AMENDED STAFF REPORT 4/22/82

CITY PLANNING COMMISSION

1. Environmental Determination
2. Special Permit to establish a private school for 40 children in an existing 1,763 square foot residential building in Single Family, R-1, and Garden Apartment, R-2B, zones.

001952
APPLIC. NO. P-82-071

EXHIBIT "B"

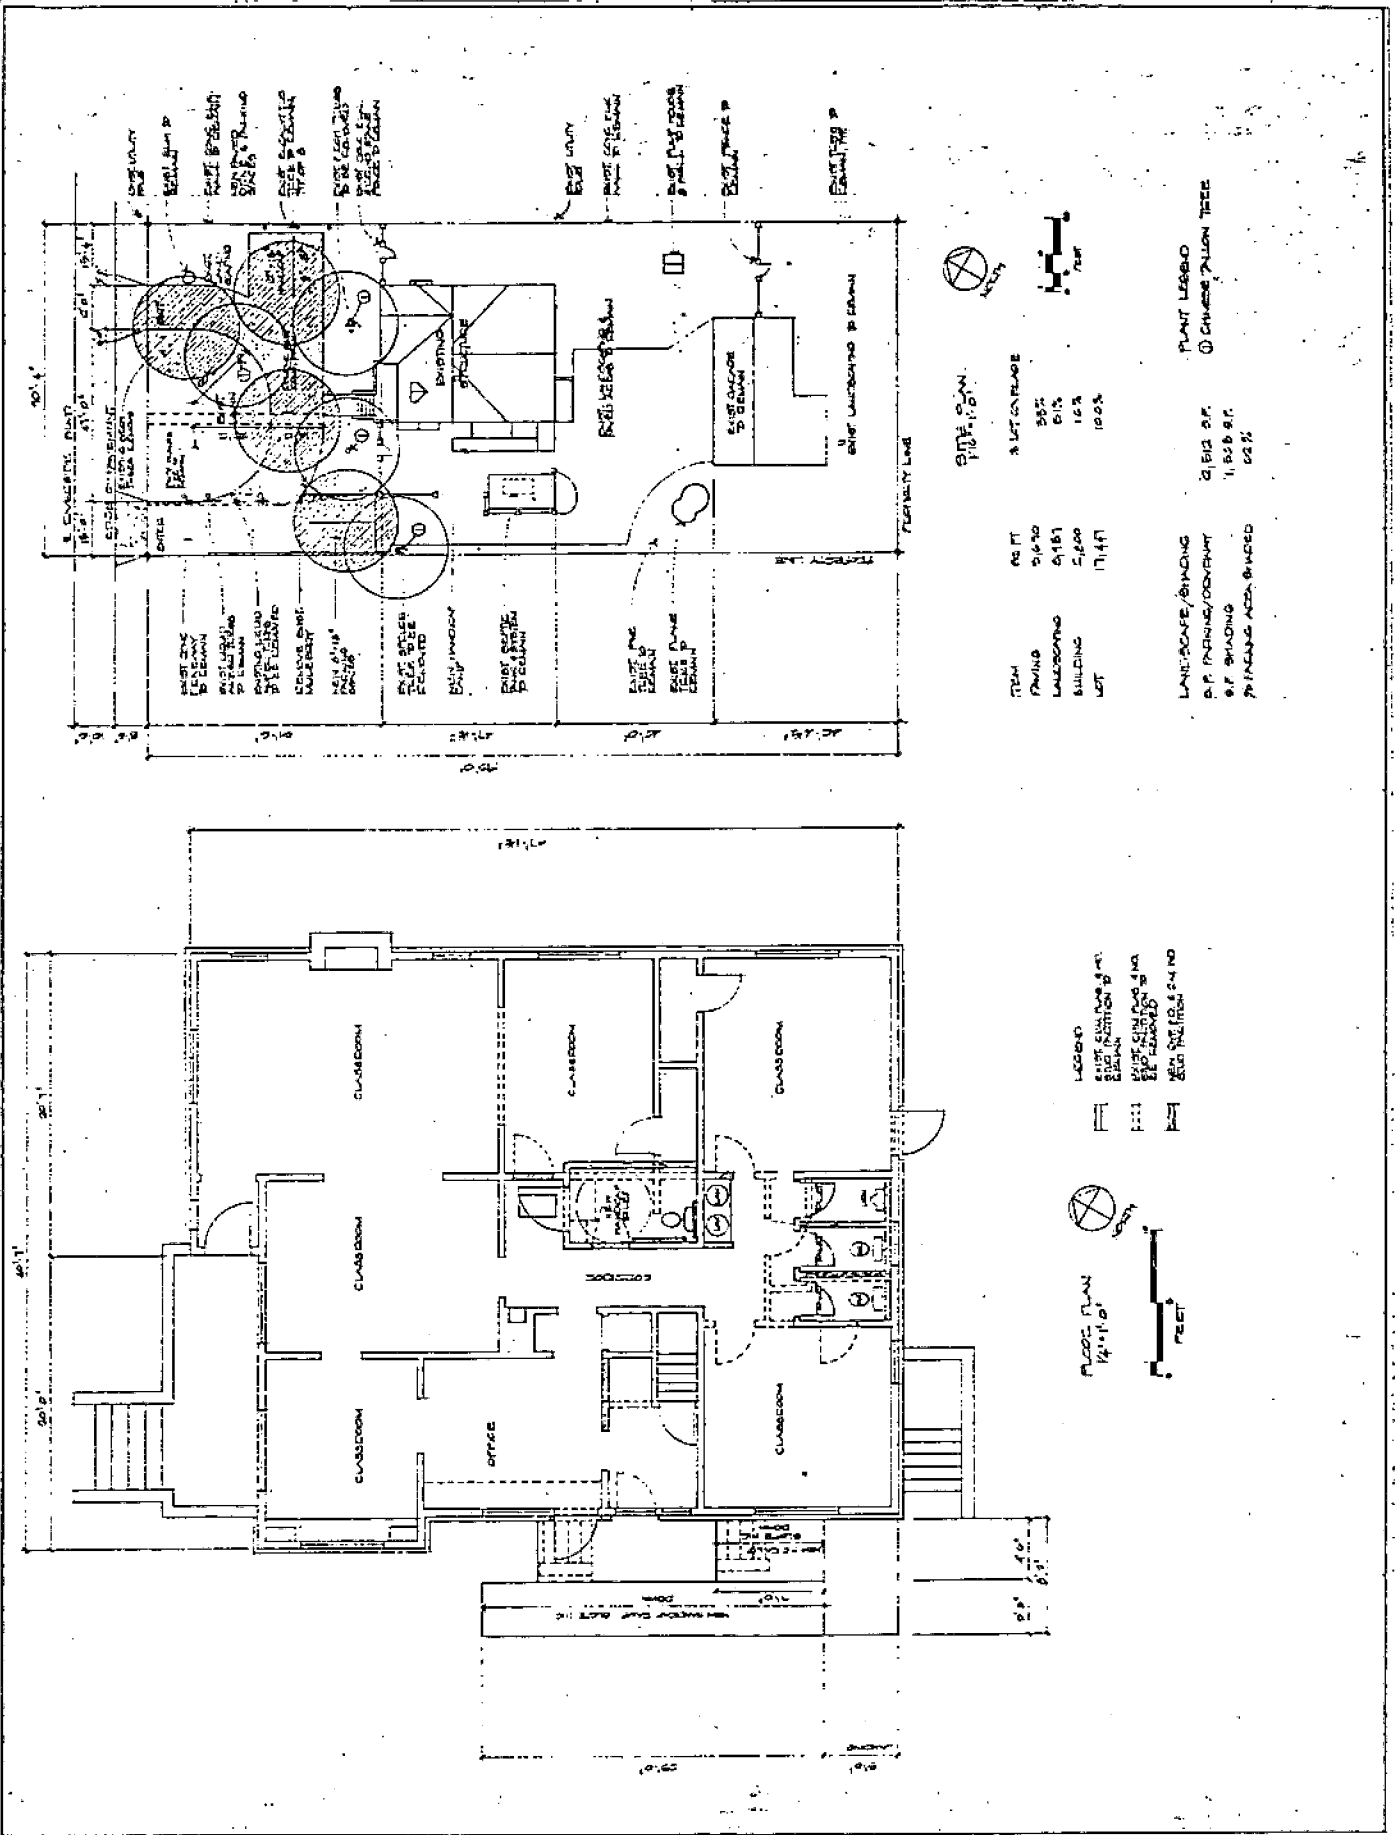
2. The City Engineering Department has indicated that the owner must dedicate approximately eight feet of right-of-way for future street widening and improvement. The applicant's site plan, Exhibit A, would have to be redesigned to eliminate parking in the front setback. Staff suggests the site plan be redesigned per Exhibit B. This would provide three parking spaces for the teachers and two spaces for parents/guests. These parking spaces, as well as the circular drive, must be paved according to the City Zoning Ordinance.

- c. The structure shall comply with City Building and Fire Code standards (E-1 Occupancy).
- * d. The applicant shall revise the parking design as indicated by Exhibit B. *The concrete curbing shall be replaced by wood headers.*

DEDICATE HALF SECTION FOR RIVERSIDE BOULEVARD

8'-0" DEDICATION STREET R.O.W.

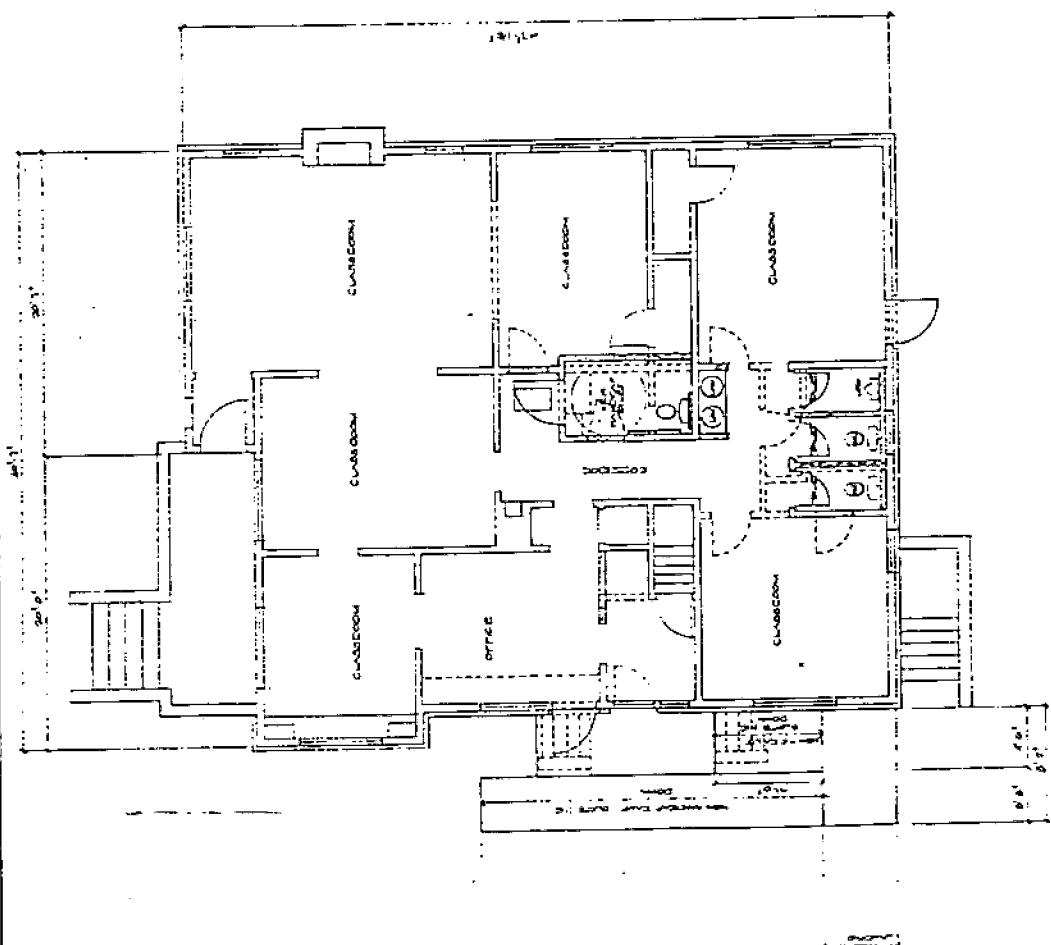
4. The applicant must submit a landscape plan indicating 50 percent shading of the parking lot as required by the Energy Conservation Ordinance (Ord. 4454) prior to the issuance of a building permit.

5. The applicant is required to install a solid six-foot high masonry wall and adjacent to the residential uses to the east, south and west as per Exhibit A under the Zoning Ordinance, Section 3-D-7 (Ordinance No. 4304-Walls and Fences). The required walls will reduce the visibility and noise transmitted from the children playing to the adjacent residences and apartments.

- * b. The applicant shall provide a decorative masonry wall on the east, south and west property line as per Zoning Ordinance Section 3-D-7 (Ord. No. 4304). This wall shall be painted to be compatible with the structure (see Exhibit A). *Bond to be posted to insure construction of the wall by 9-8-83 prior to occupancy.*

- * e. The applicant shall apply for lot line merger on Parcels A and B (see Exhibit A) so that the driveway and parking area shall be on one parcel. *This must be completed prior to issuance of this special permit. The lot line merger must be recorded prior to issuance of Special Permit.*
